PIMA COUNTY
REGIONAL FLOOD CONTROL DISTRICT
97 EAST CONGRESS STREET, THIRD FLOOR
TUCSON, ARIZONA 85701-1797

**Re: Response to Incomplete and Incorrect Determination for Underground Storage Facility
Application No. 71-563876.0006**

We have reviewed your October 9, 2007 letter and have addressed the items you have listed:

**FIGURE 2 FACILITY MAP
MAP VIEW**

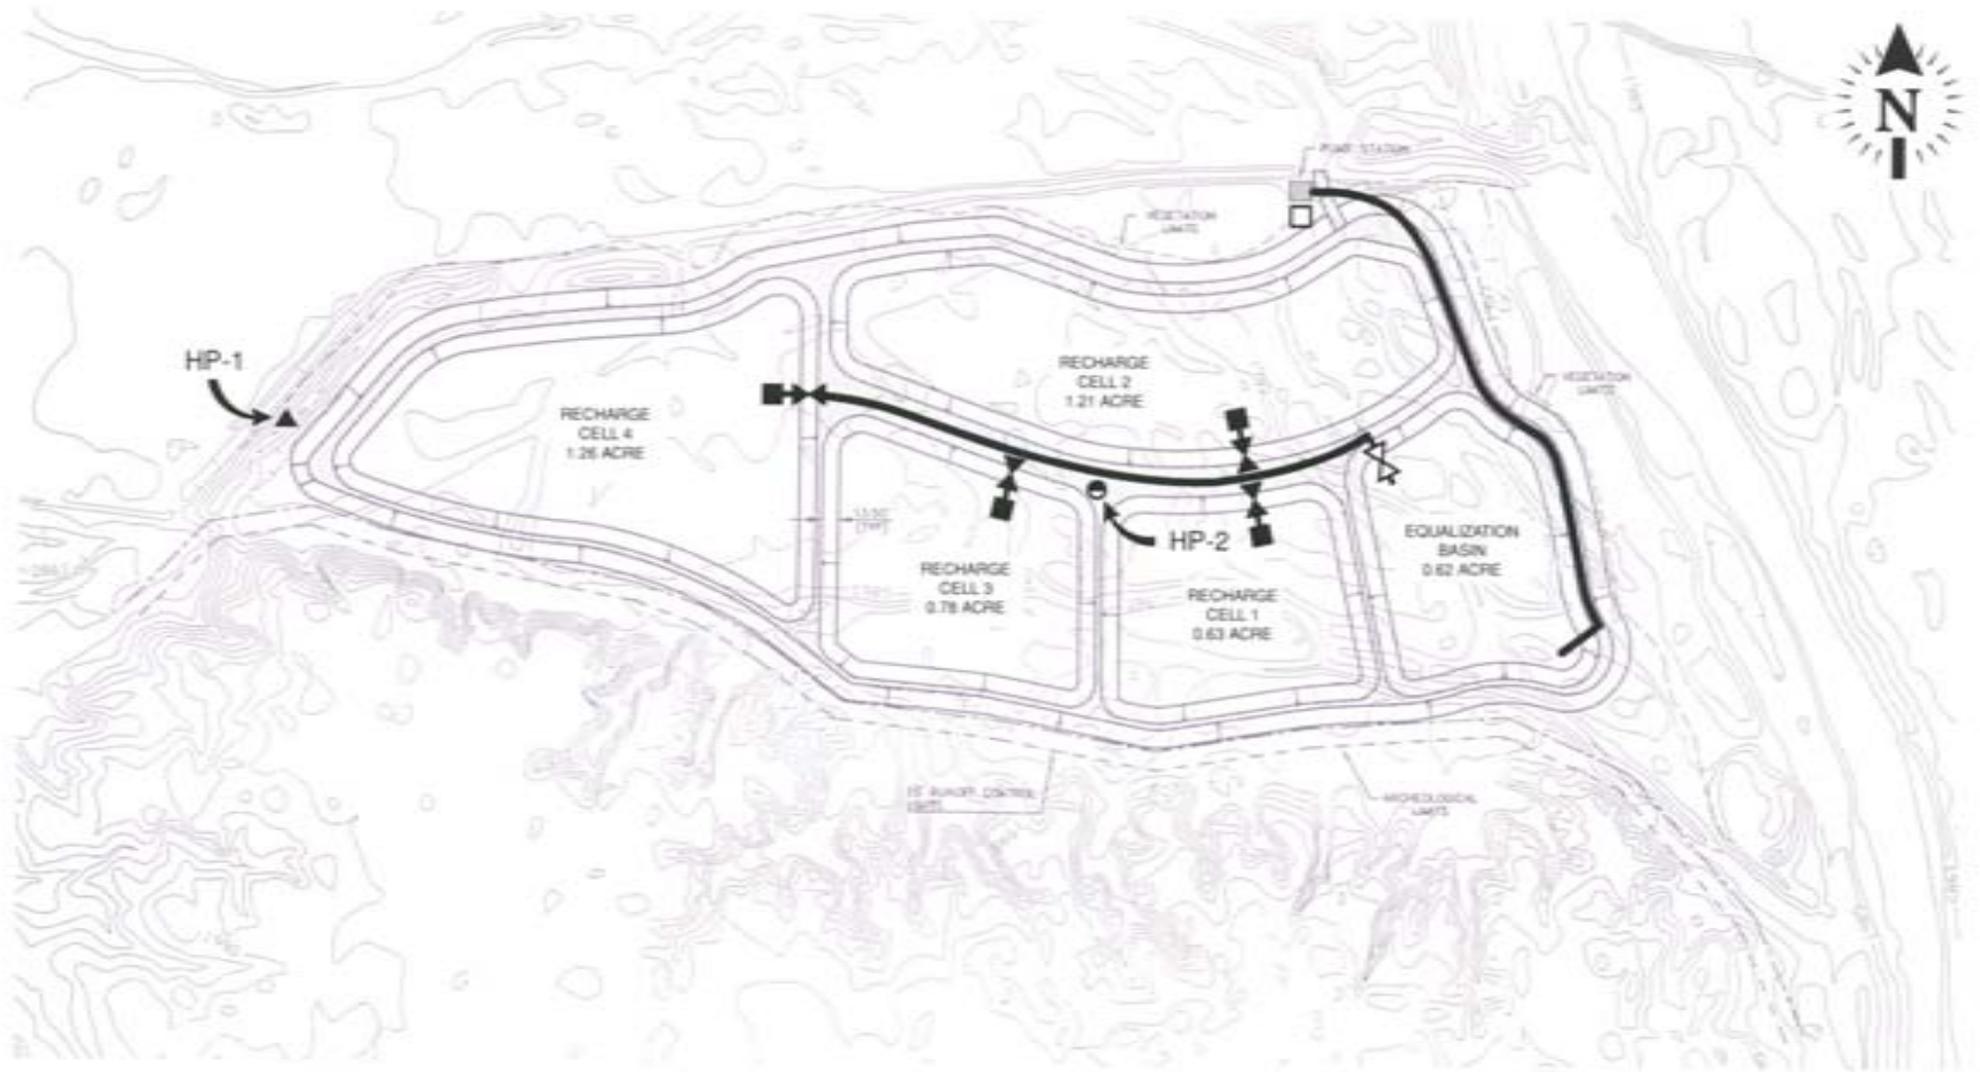
Bullet #1: Figure 2 has been modified to include the distribution pipelines, flow meters, and the manual and automated valves that make up the facility's conveyance system (**Attachment 3**)

FIGURE 13
 PIMA COUNTY DEPARTMENT OF TRANSPORTATION
 AND FLOOD CONTROL DISTRICT

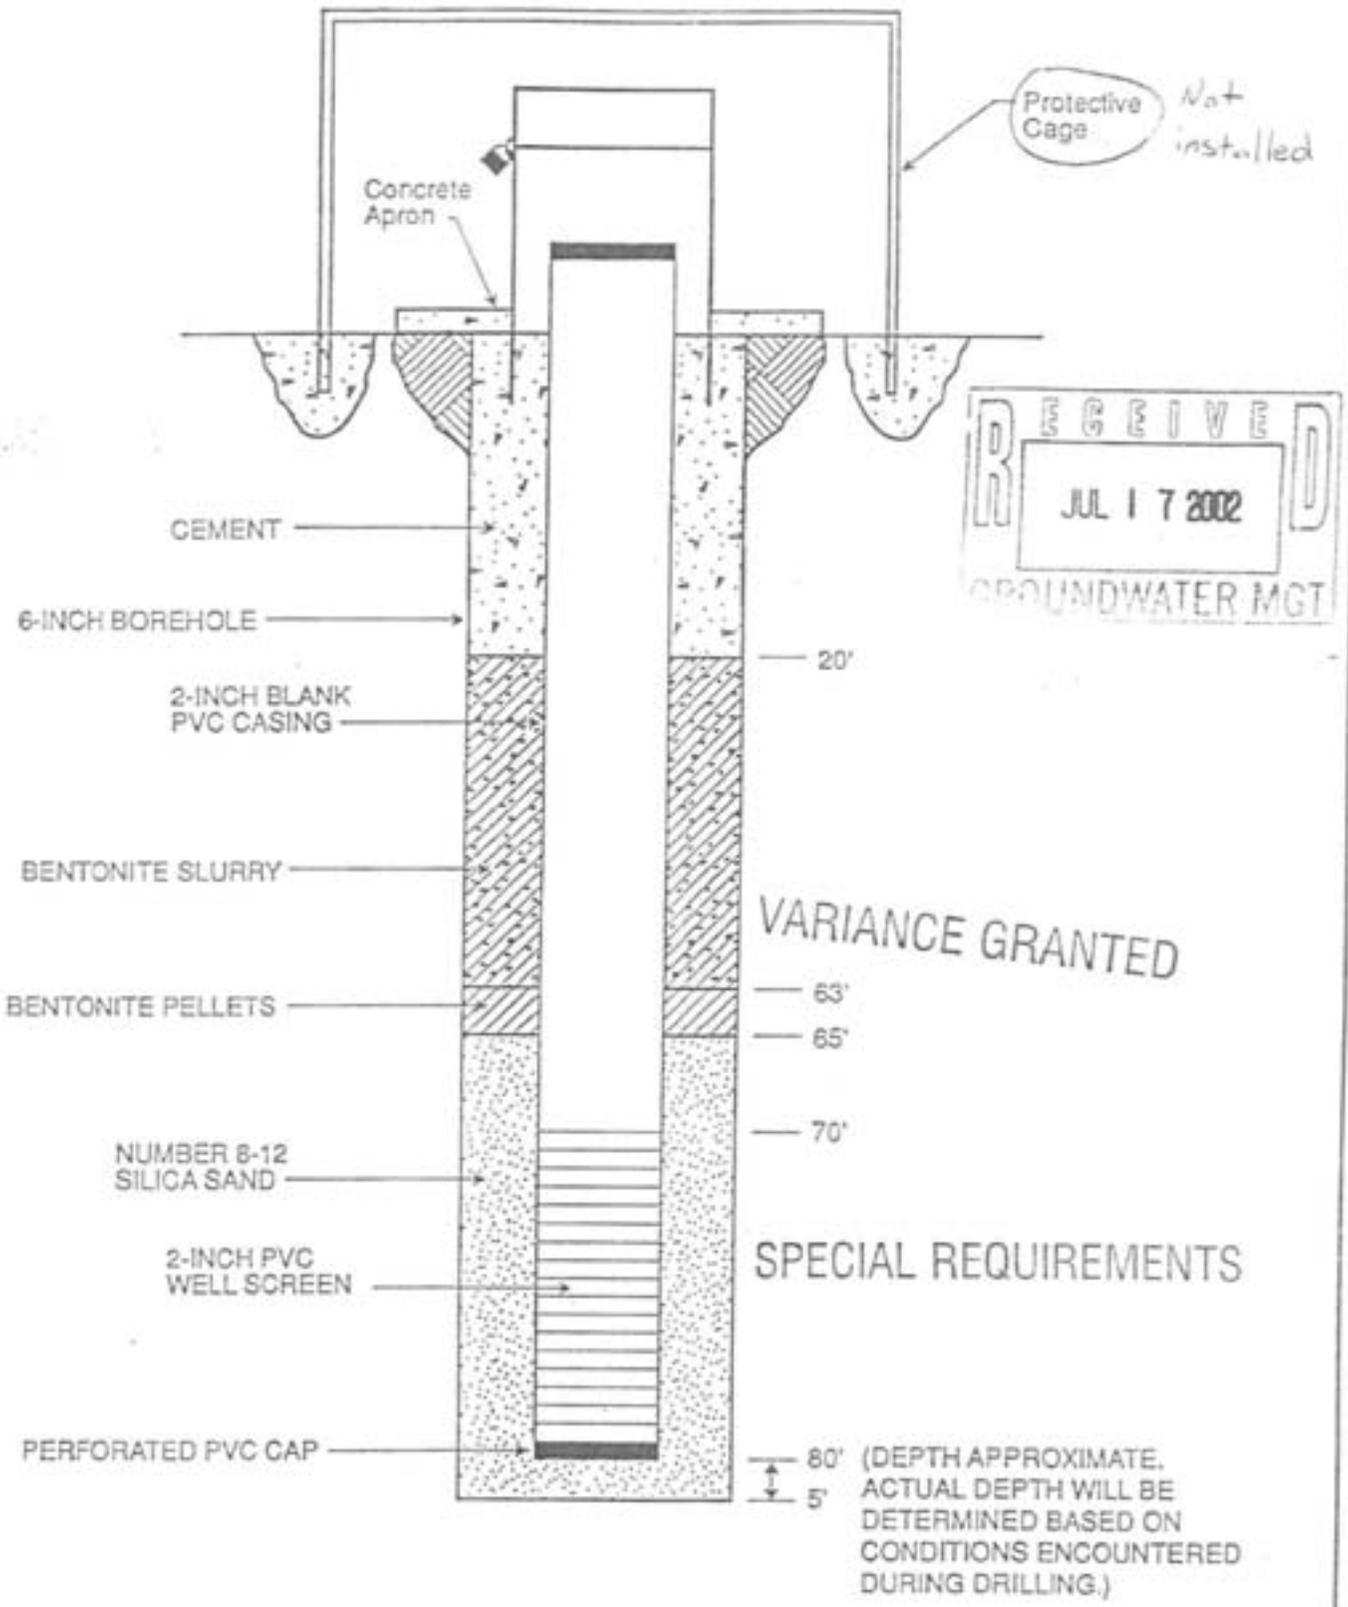
Bullet #2: Well HP-2 was built to the specifications shown on Figure 13. There is no as-built well diagram for this piezometer. A revised copy of the well diagram (Figure 13) is provided for reference (**Attachment 4**).

Cross Section B-B'

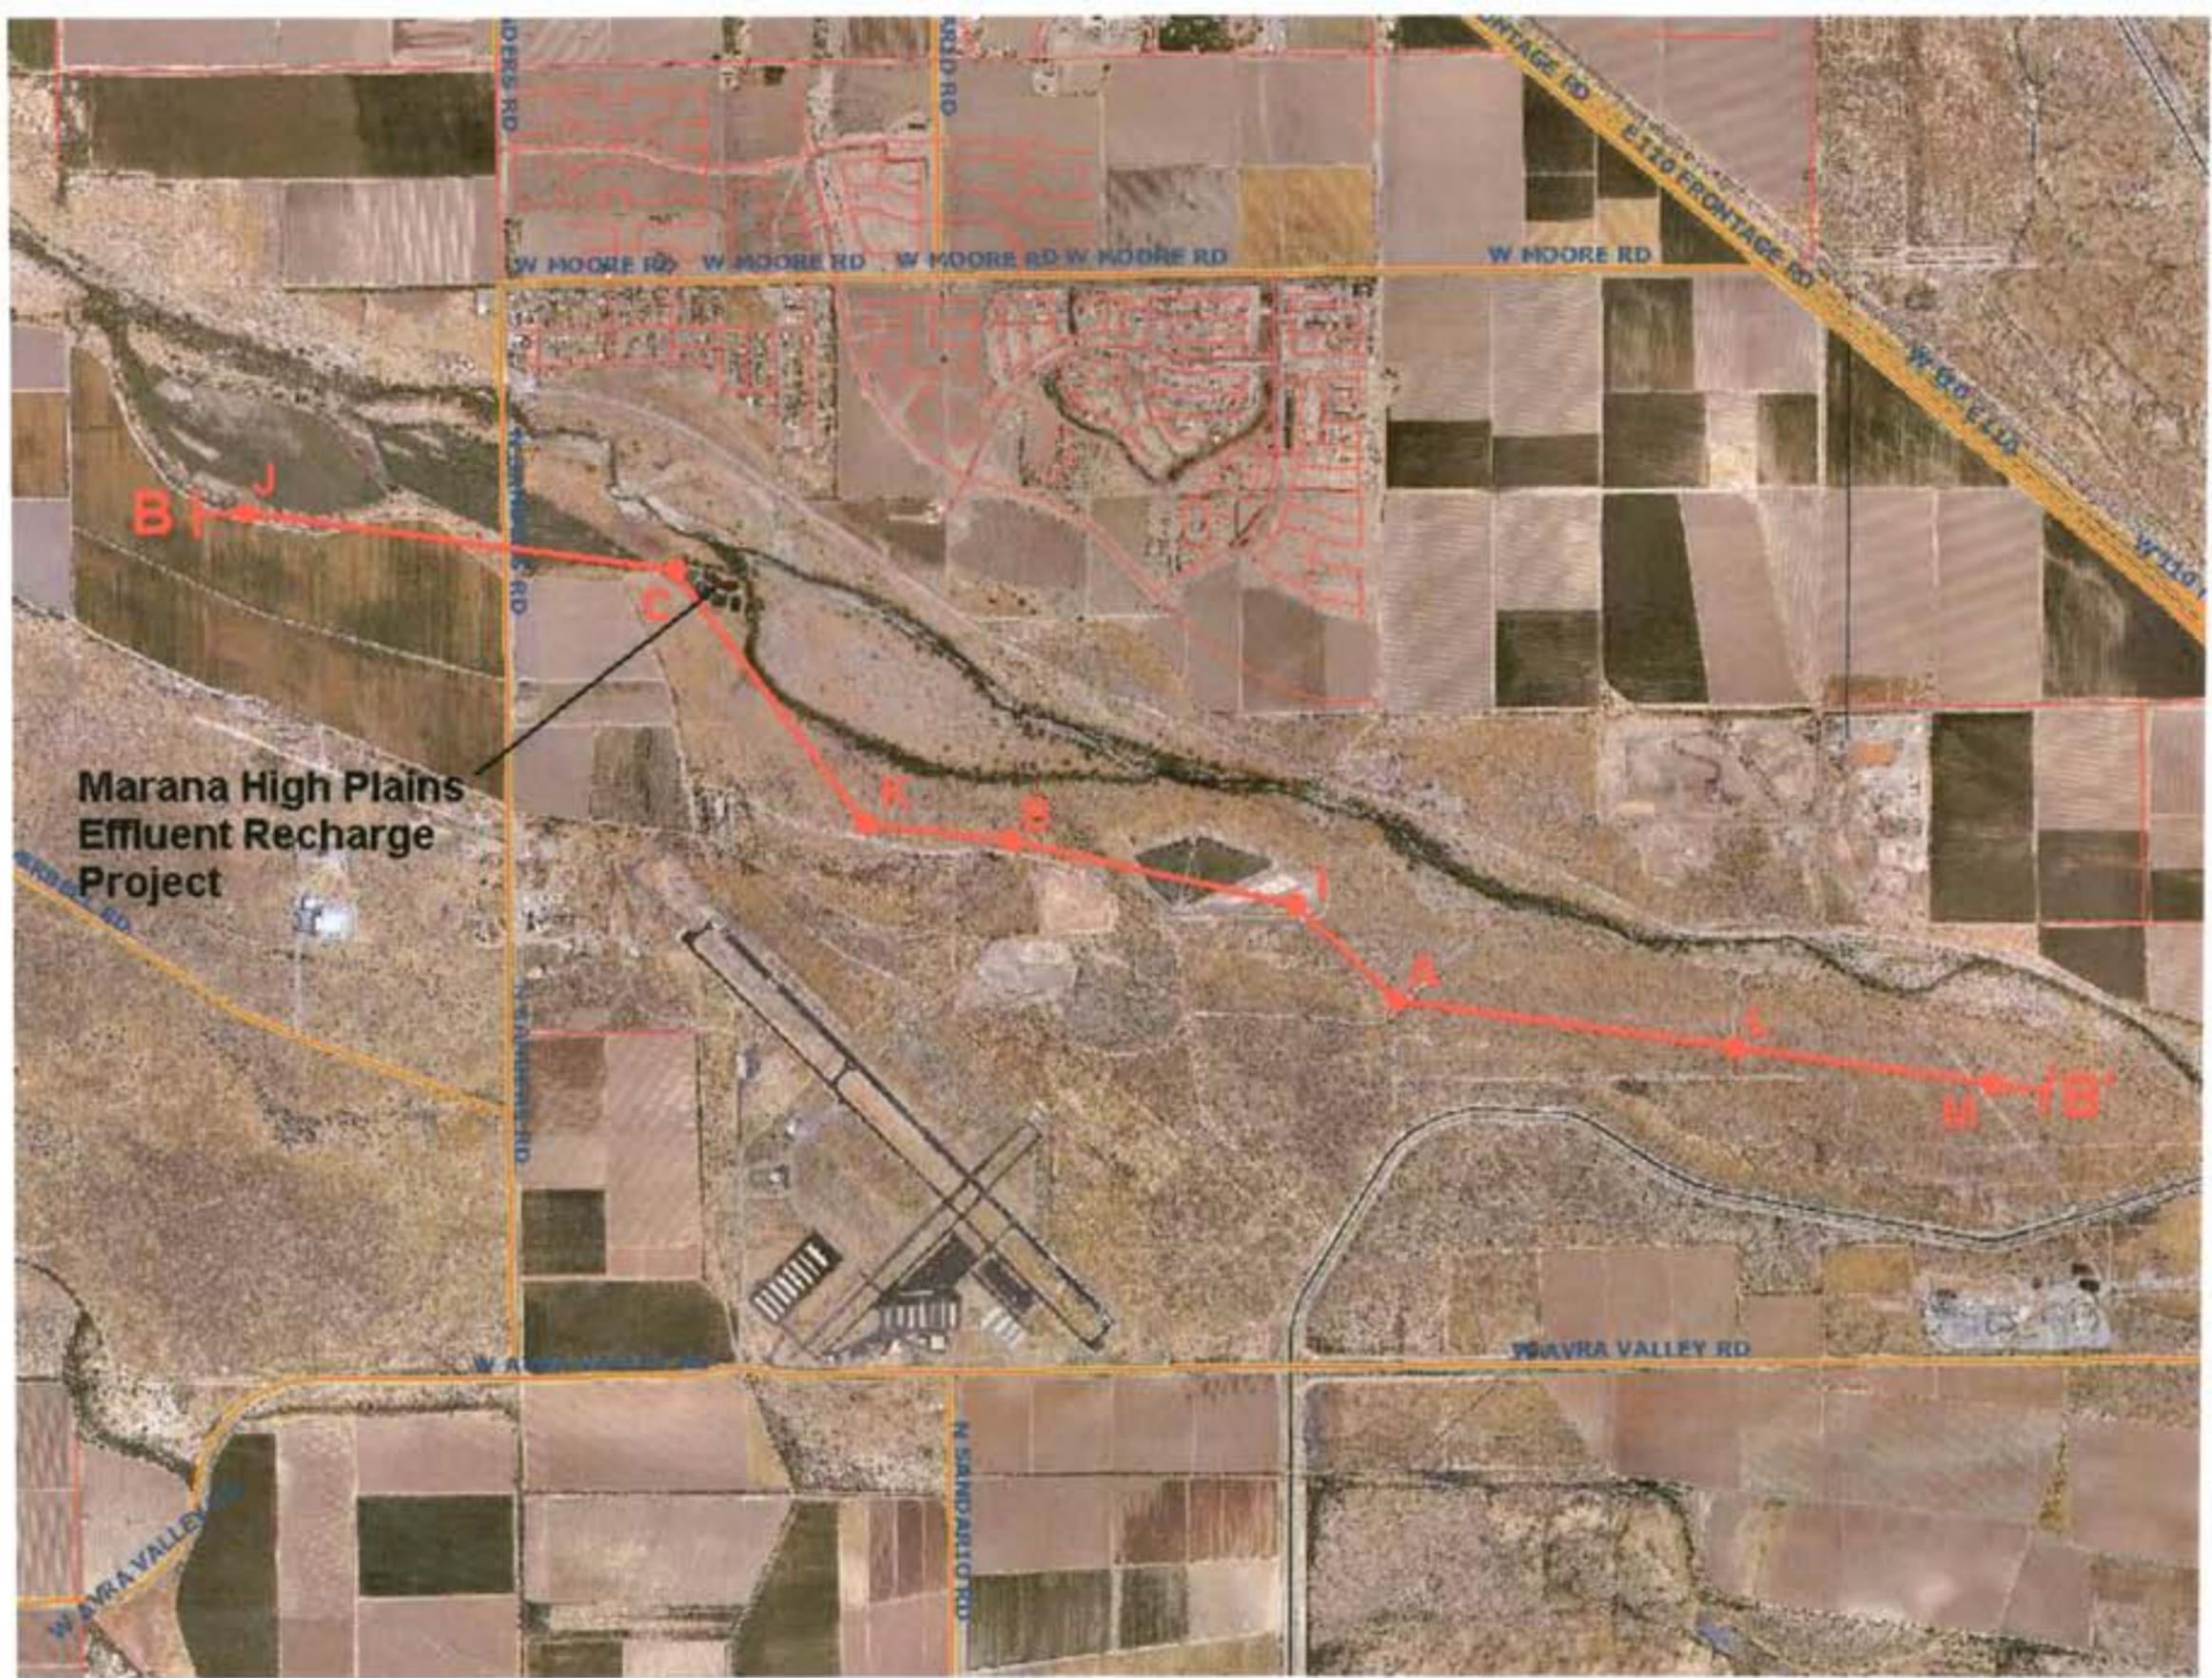
Bullet #3: A map view of cross-section B-B' is enclosed along with the well driller's logs for all the wells that were used to construct the cross-section (**Attachment 5**).
